DEPARTMENT OF TRANSPORTATION

49 CFR Parts 567, 571, 574, 575, and 597

Tire Safety Information

ACTION: Final rule; response to petitions for reconsideration.

Figure 1

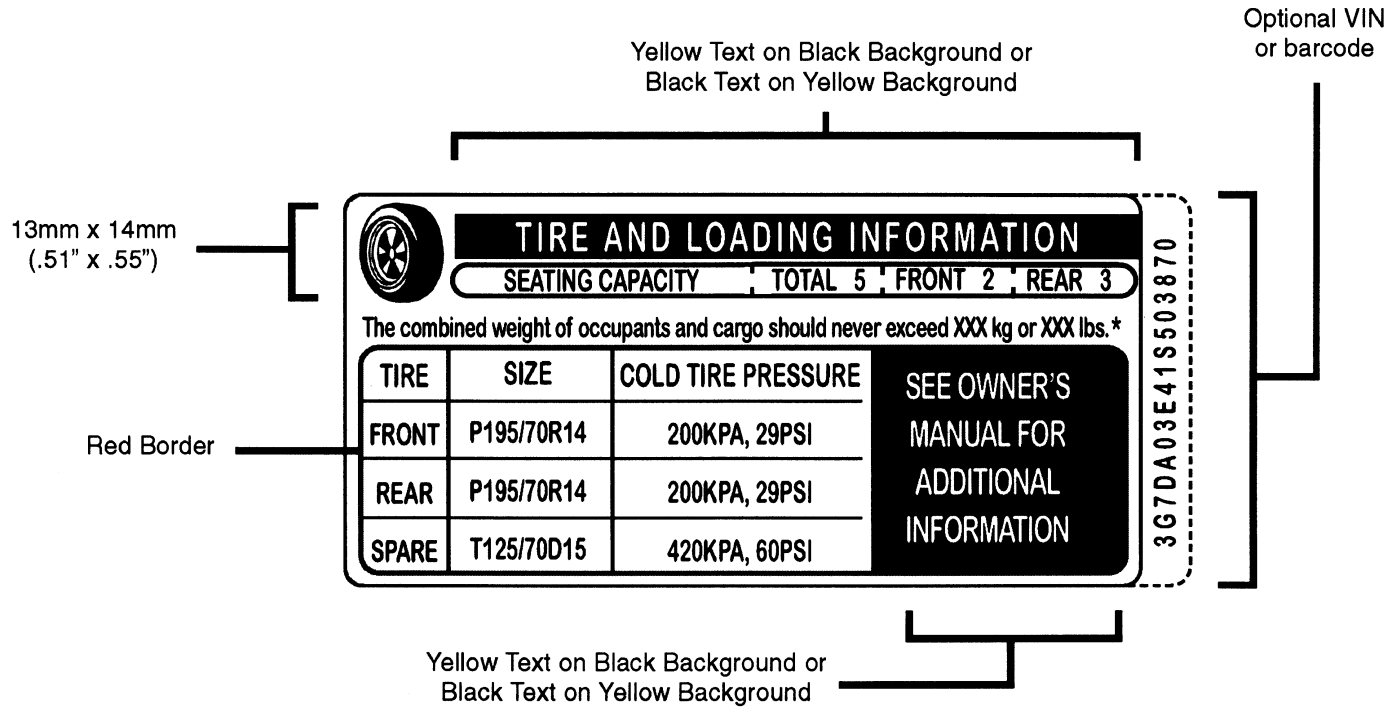
- The chart within the Vehicle Placard of Figure 1 is re-formatted to be identical to the chart within the Tire Inflation Pressure Label of Figure 2.
- Reference to “occupants” is be removed from trailer placards and trailer owner’s manuals, and
- Incomplete and intermediate vehicle manufacturers are not allowed to affix a placard to an incomplete vehicle.

Vehicle Placard in Figure 1 so that the chart within the placard is formatted identically to the chart within the Tire Inflation Pressure Label in Figure 2. We conclude that the chart currently found within Figure 2 is better organized than the chart currently found within Figure 1. We believe that the uniform use of a single chart format will enable consumers to better understand the necessary tire information. Additionally, in those rare instances where a vehicle is equipped with front and rear tires of different sizes, the chart format from the Figure 2 will allow a manufacturer to identify different tires sizes for front and rear tires. The Vehicle Placard in Figure 1 has been revised accordingly. This rule contains updated examples of the Vehicle Placard and the Tire Inflation Pressure Label.¹⁵

* For trailers, this statement should read:
The weight of cargo should not exceed XXX kg or XXX lbs.

Figure 2

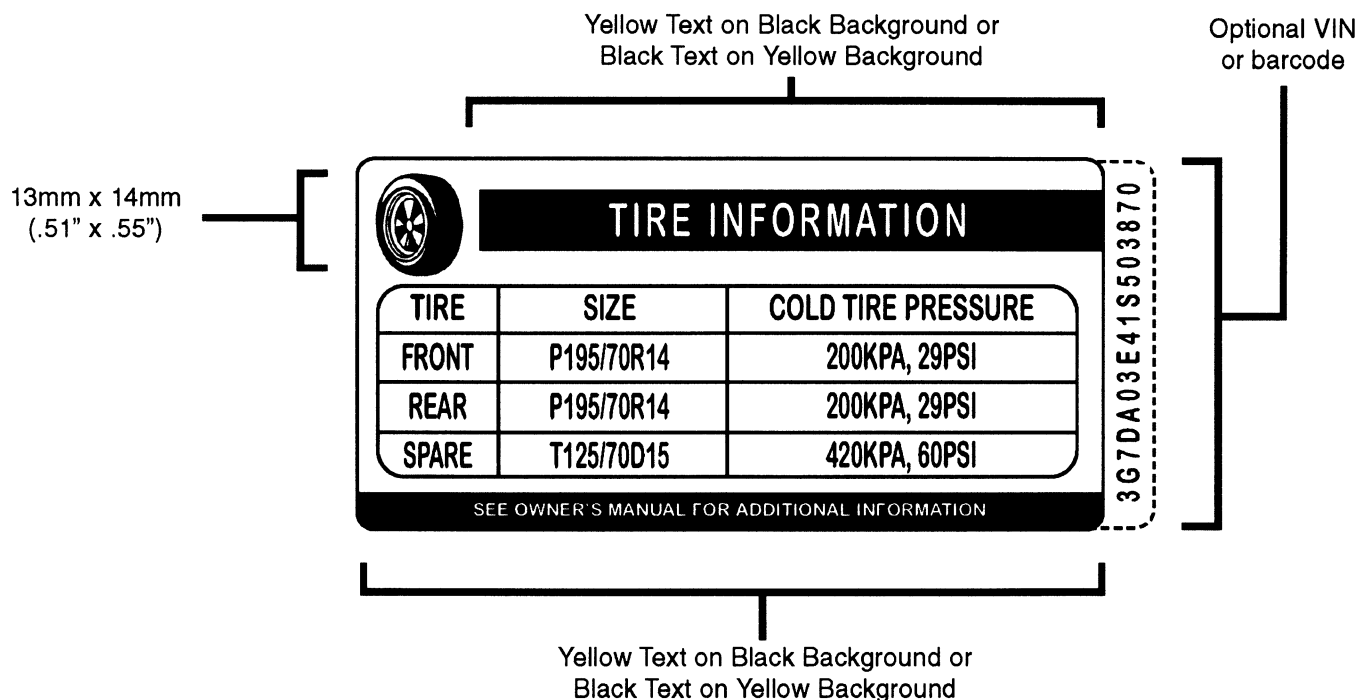
¹⁴ We note that Figure 2 of the November 2002 final rule incorrectly contained the load index and the speed category symbol. This document contains corrected figures depicting the tire information label and the tire placard. The load index and the speed category symbol have been excluded from the revised figures.
